BARNEYS CANYON MINE
WASTE ROCK MANAGEMENT PLAN

Revised on May 27, 1994

Re: Waste Rock Management Plan,
Ground Water Discharge Permit
No. UGW350001

FIGURE 1
COMPONENTS OF DUMP DRAINAGE

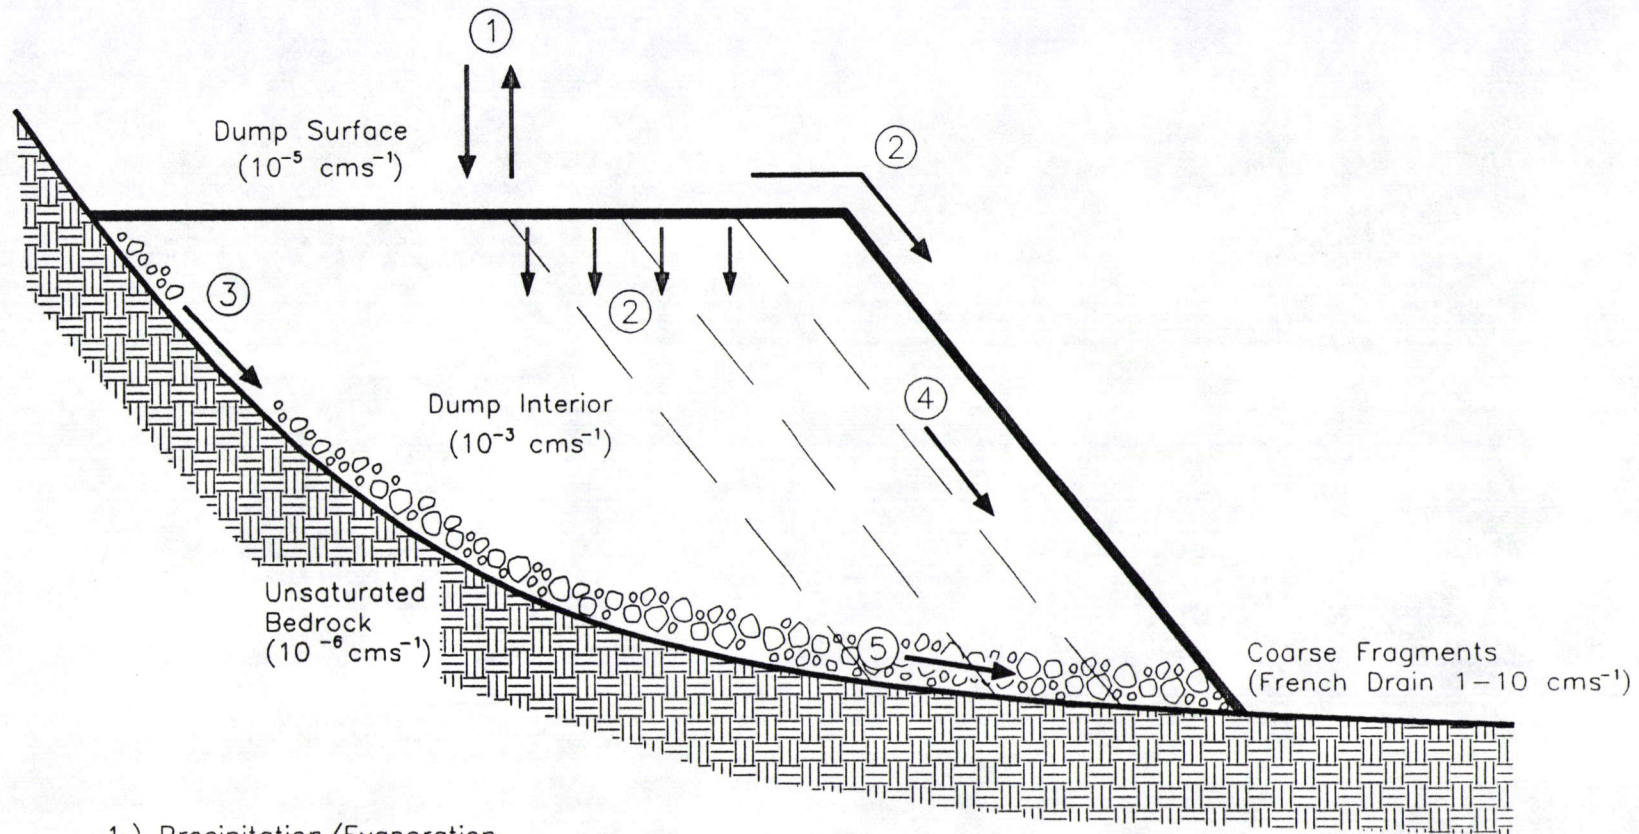
The Waste Rock Management Plan describes the conceptualized design plans for dump construction. One conceptual design cross section, Figure 1, Components of Dump Drainage, is provided in the plan. Under Section 4.2 and 4.3, verbal descriptions of the 'Oxide' and 'Sulfide' waste dump reclamation designs are provided. Please provide a conceptualized cross-section(s) of the sulfide dump design plans for the Melco South Sulfide dump and the NBCS pit backfill.

why?
not
compaction?

SITE PLAN

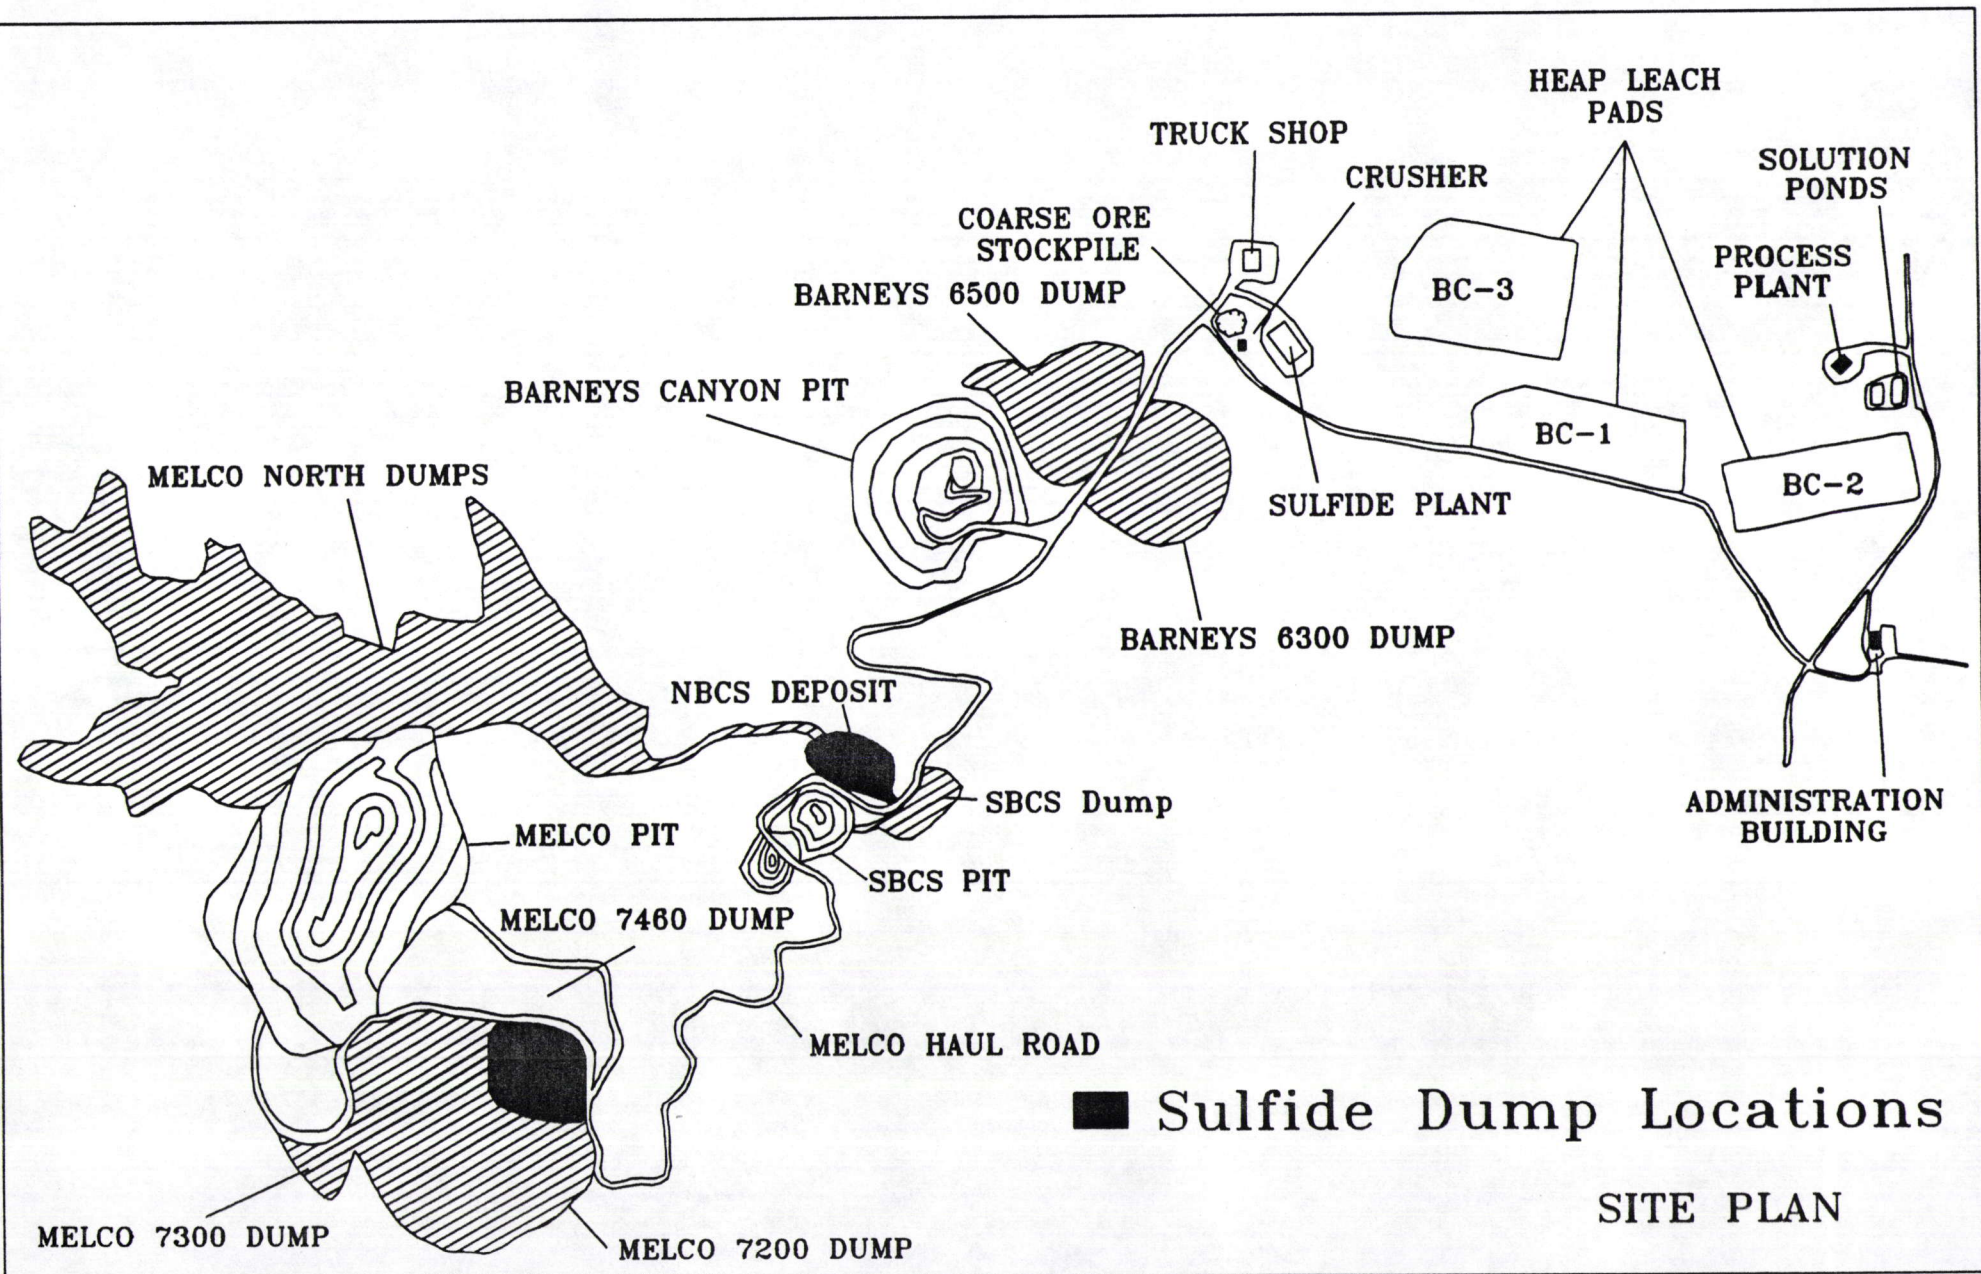
E. The proposed Melco South dump is not located on the map (site plan). The NBCS dump should also be labeled.
